DATE: April 3, 2019

AGENDA ITEM # 2

TO: Design Review Commission
FROM: Sean K. Gallegos, Associate Planner
SUBJECT: 18-SC-10 – 1160 Eureka Avenue

This is a design review application for a new two-story house. The project includes 2,836 square feet on the first story and 1,315 square feet on the second story. This application was previously reviewed by the Design Review Commission on December 19, 2018. The following table summarizes the project's technical details:

DRAWN
CHECKED
DATE 1.15.18
SCALE 1/4" = 1'-0"
JOB NO. TSAI
SHEET A4
OF SHEETS

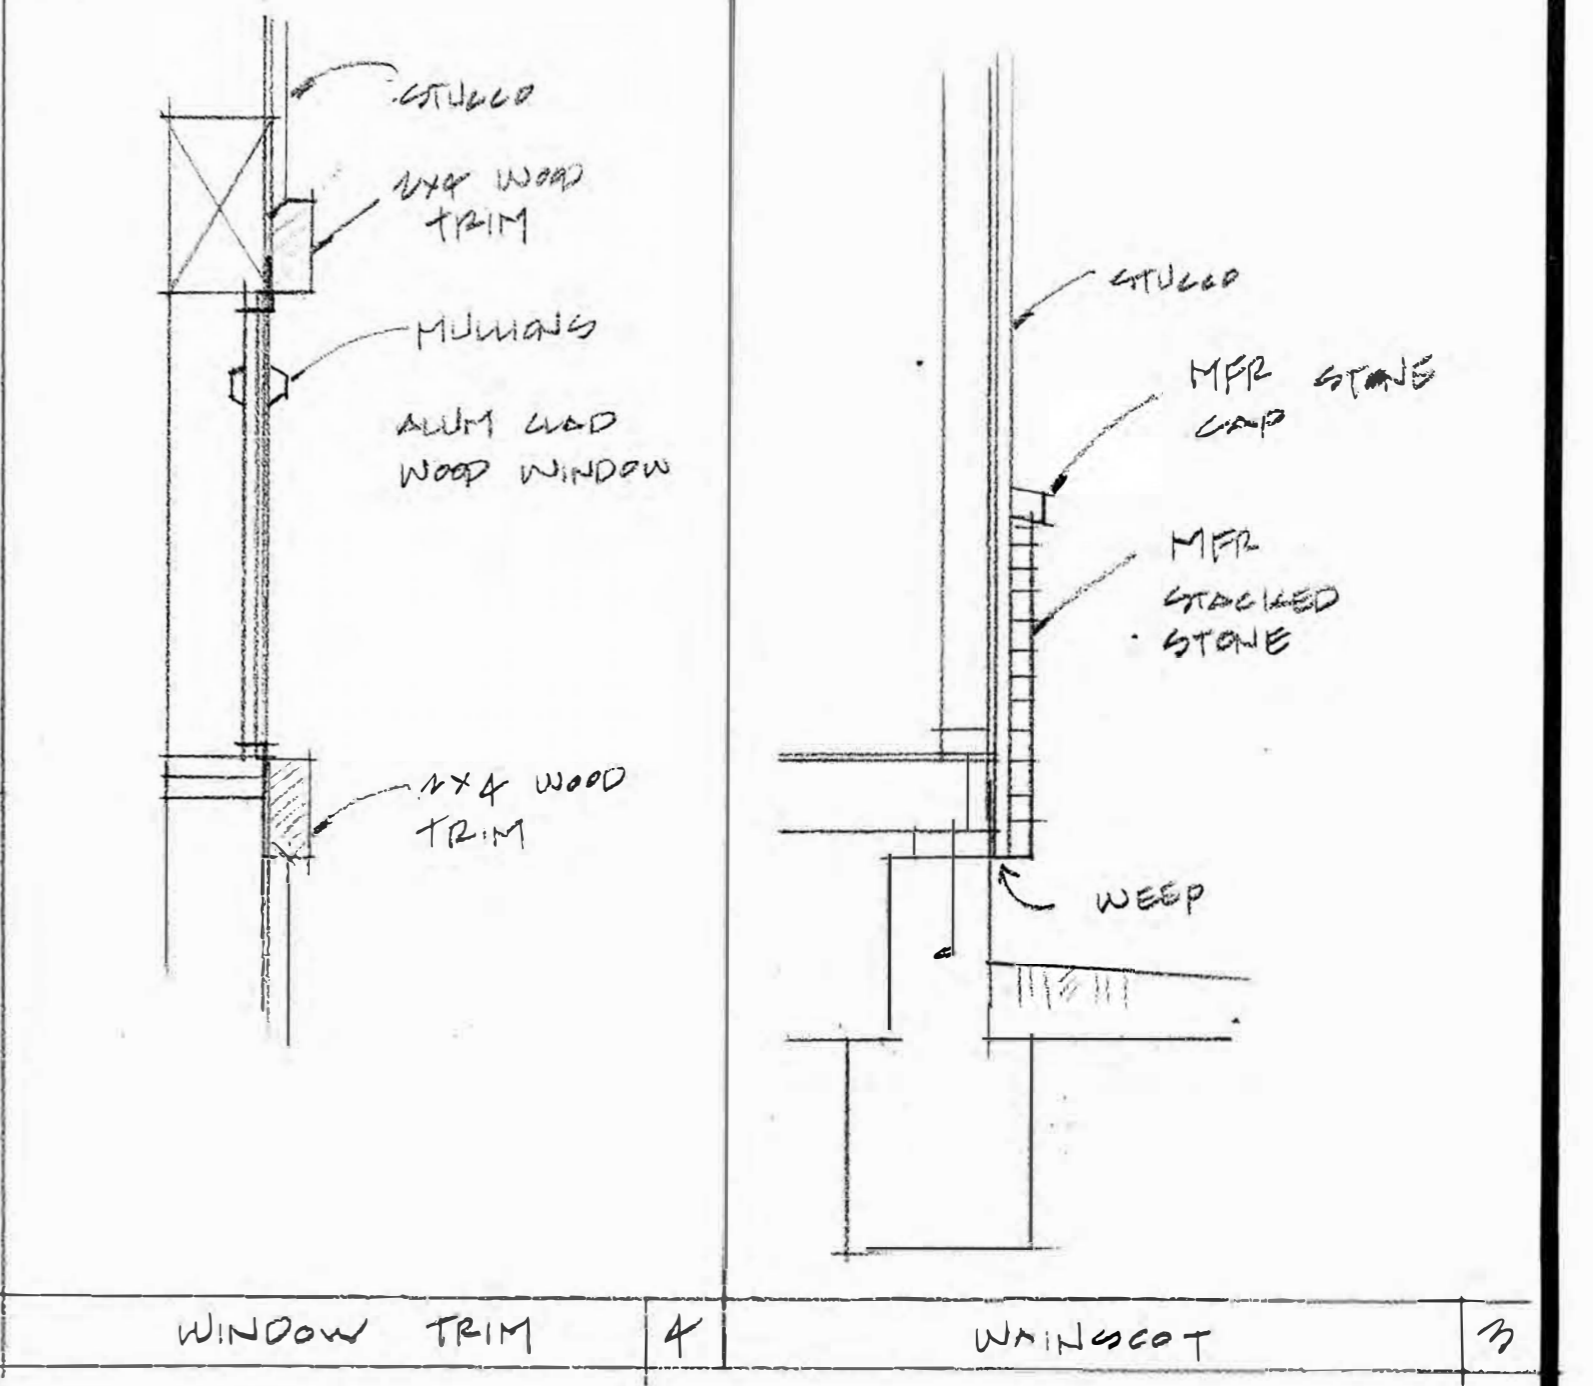
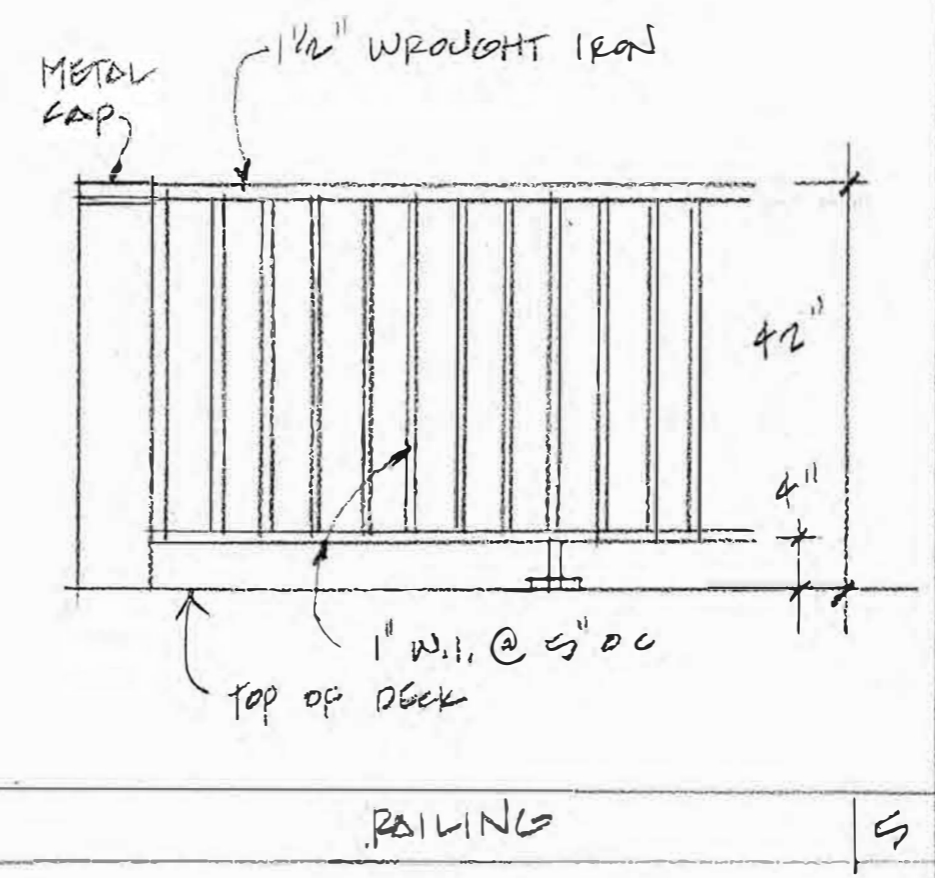
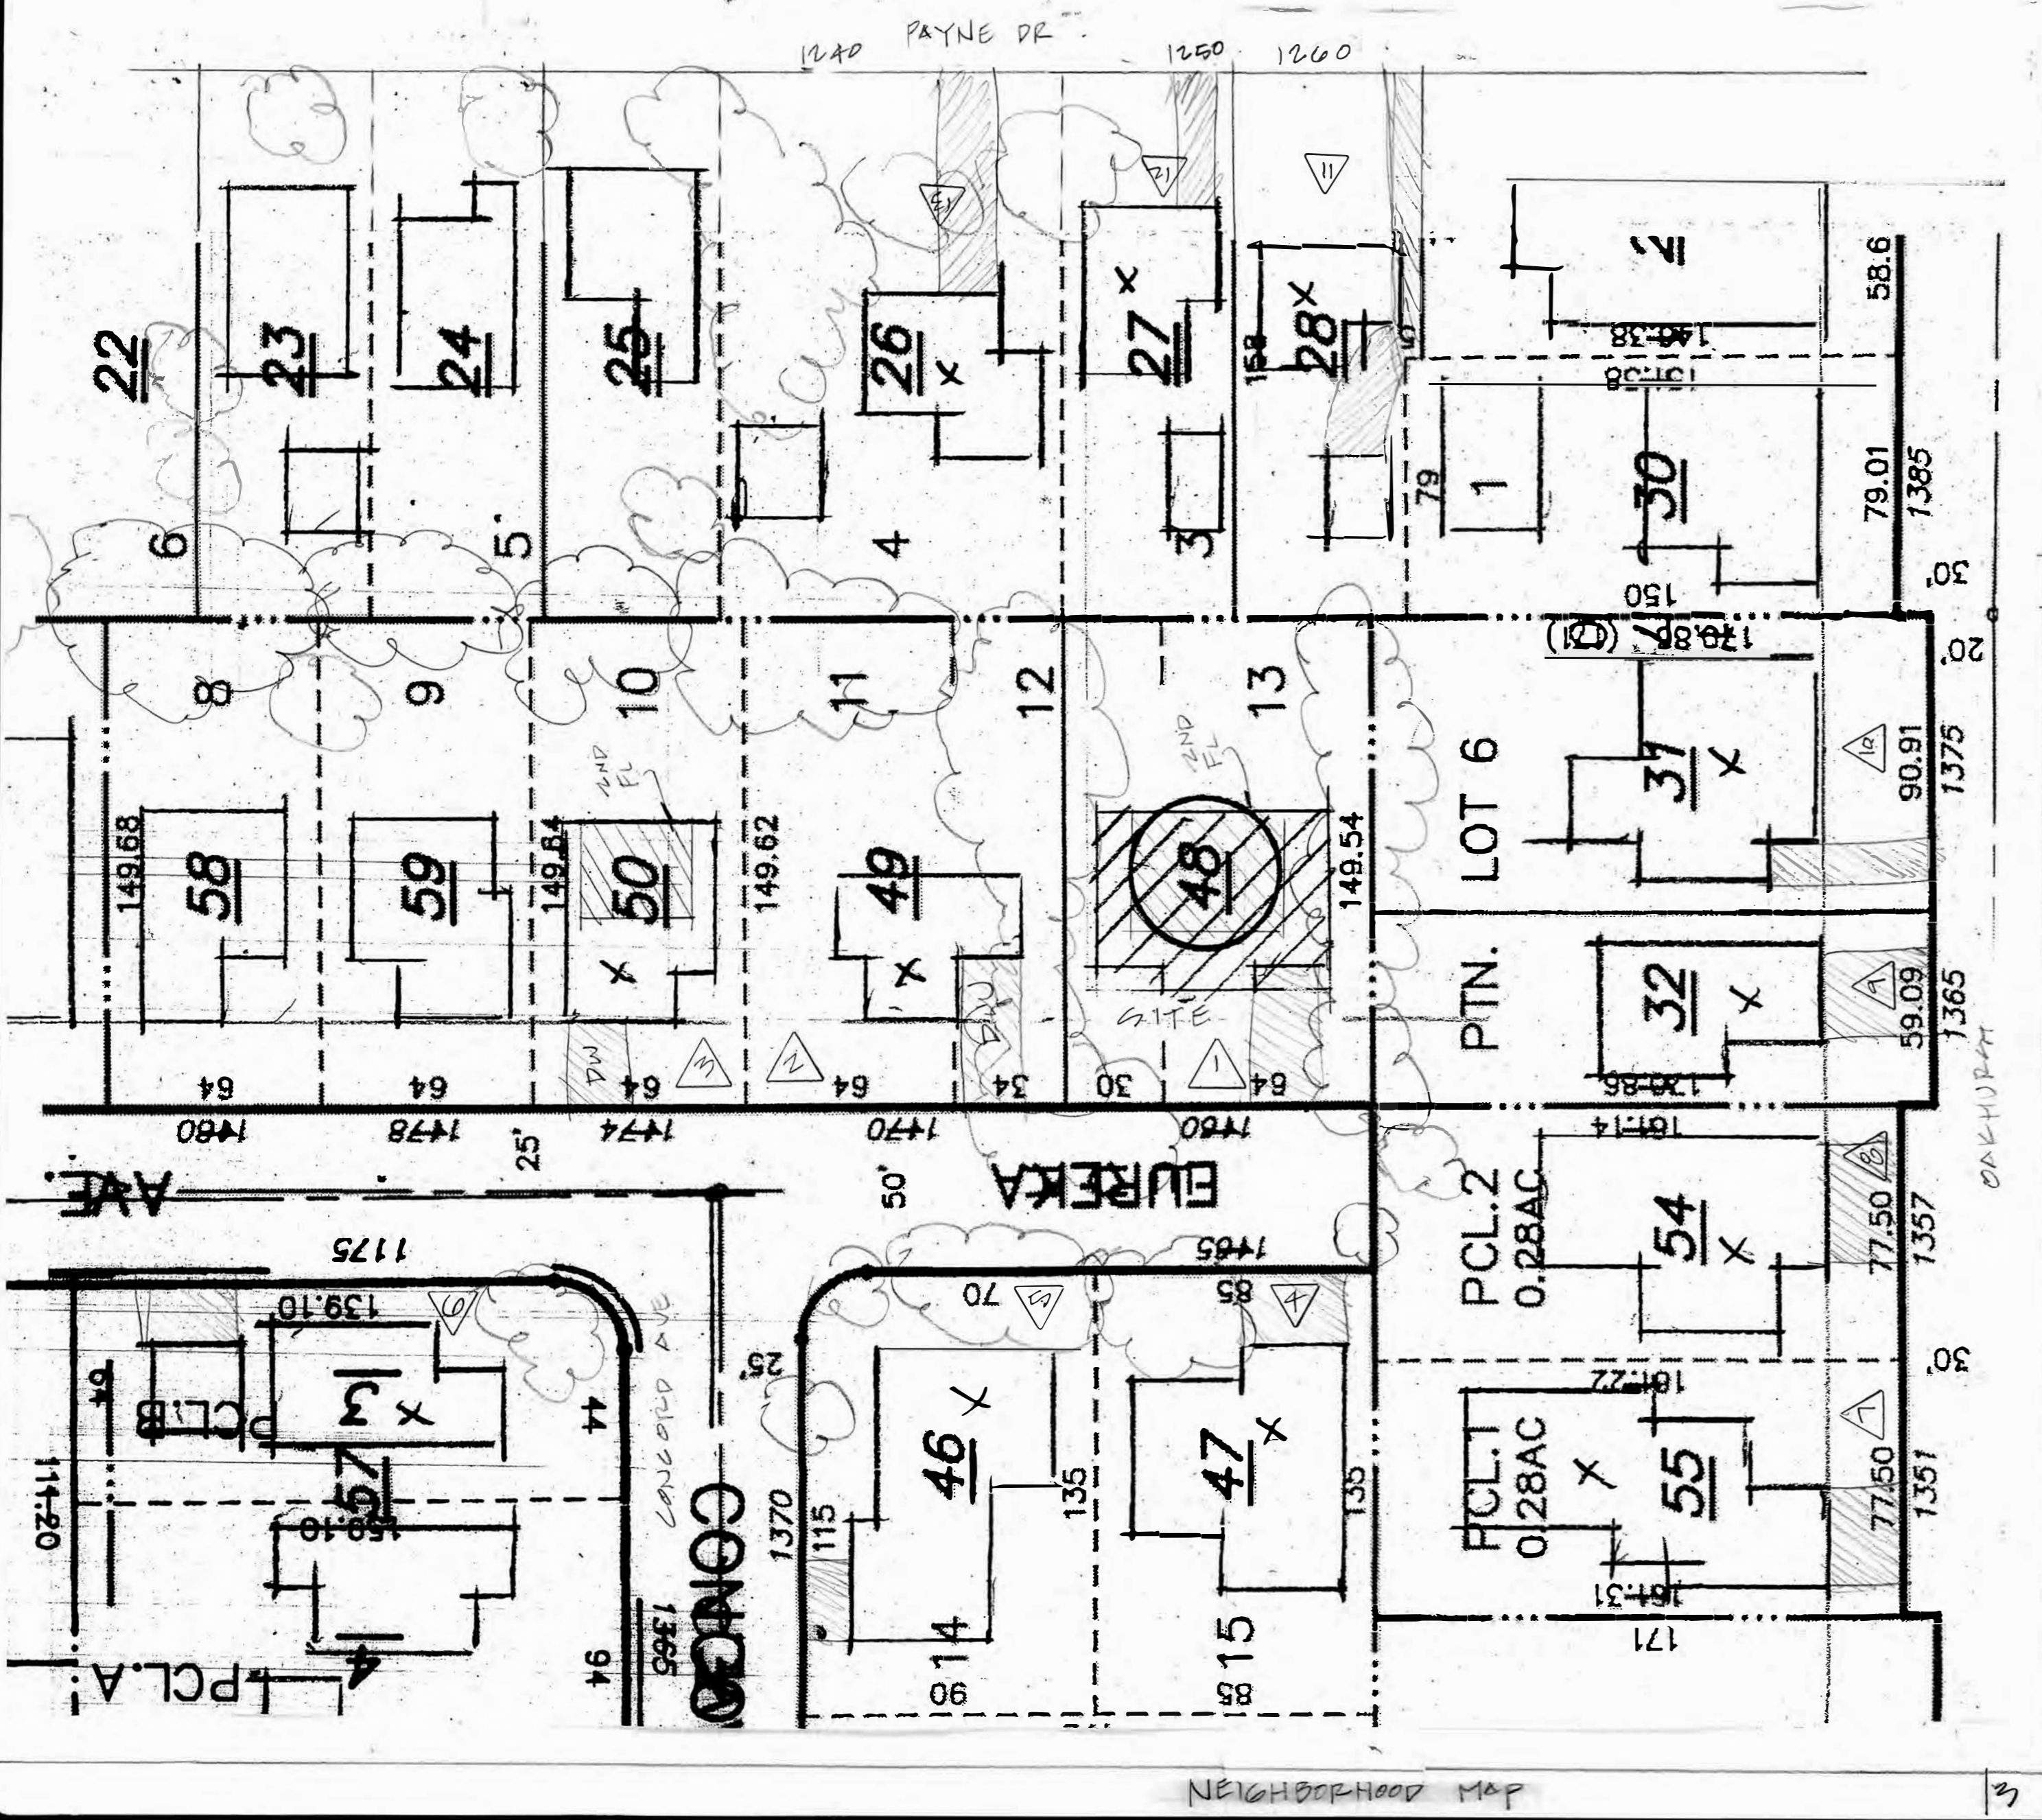
- Revise the design with more detail;
- Provide a colored 3D rendering; and
- Communicate with the neighbors regarding fence replacement and provide a fence replacement plan.

- Revise the design with more detail;
- Provide a colored 3D rendering; and
- Communicate with the neighbors regarding fence replacement and provide a fence replacement plan.

- The elevations have been revised to better illustrate the proposed composition shingle roof material;
- The overall window and door style and pattern along the front rear elevation has been simplified to reduce the scale of the facades and contribute to breaking up the massing of the structure;

- The garage door has been revised to a two-door carriage garage design to reduce the overall perceived massing along the front elevation;
- To better convey the exterior design elements of the proposed project, the applicant provided architectural details of the windows, bay windows, window trim and stone wainscoting on sheets A4 and A5; and
